42 Beacon Hill Road, Beacon Hill

Geotechnical Comments for Section 4.55 (Formerly Section 96).

PRELIMINARY GEOTECHNICAL ASSESSMENT:

Photo 1

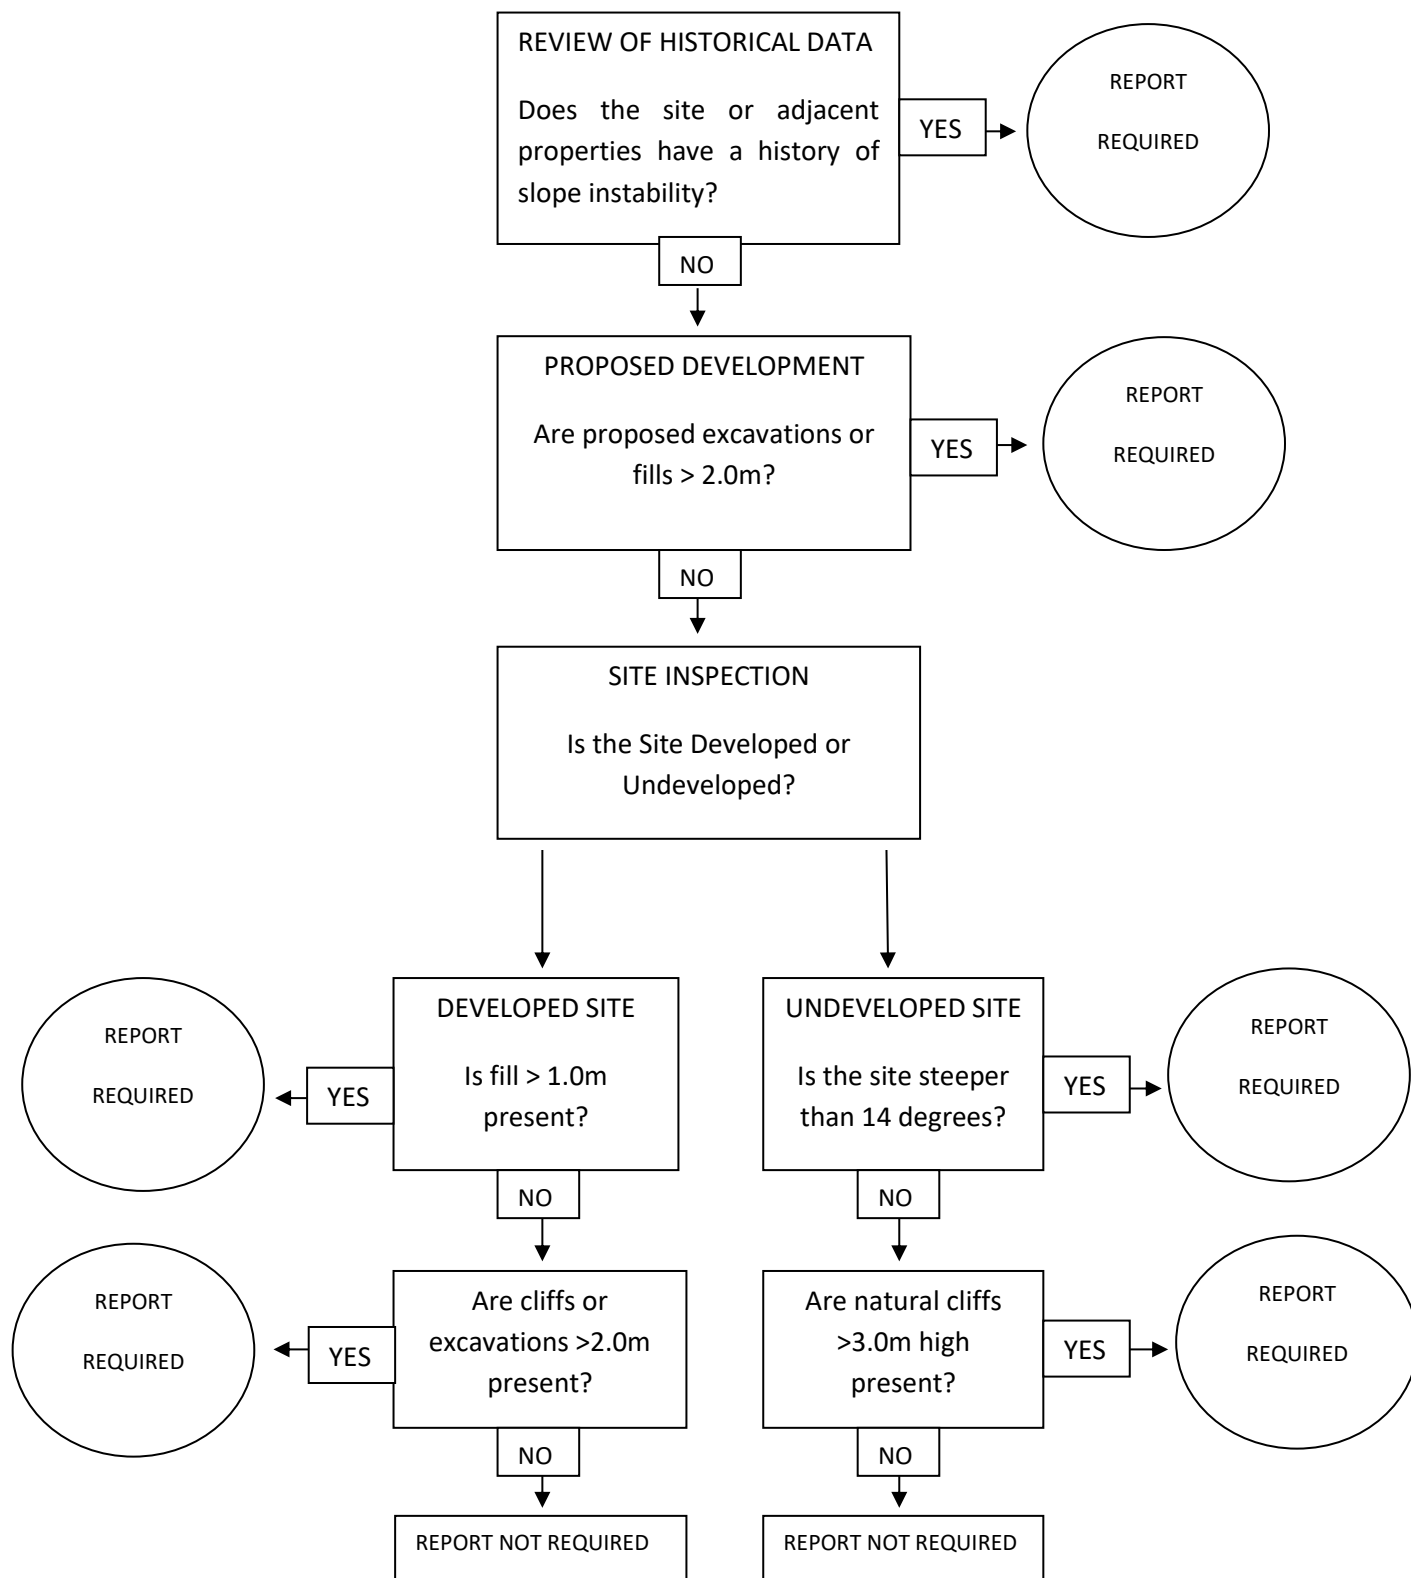
The concrete block retaining wall supporting the fill on the NW neighbouring property is cracked and shows minor settlement (Photo 1). To be prudent, we recommend the retaining wall be inspected by the owners on an annual basis or after heavy prolonged rainfall, whichever occurs first, keeping a photographic record of the inspections. We can carry out these inspections upon request. Should any new movement be observed, the geotechnical consultant is to be engaged to assess the movement and provide remedial advice if necessary.
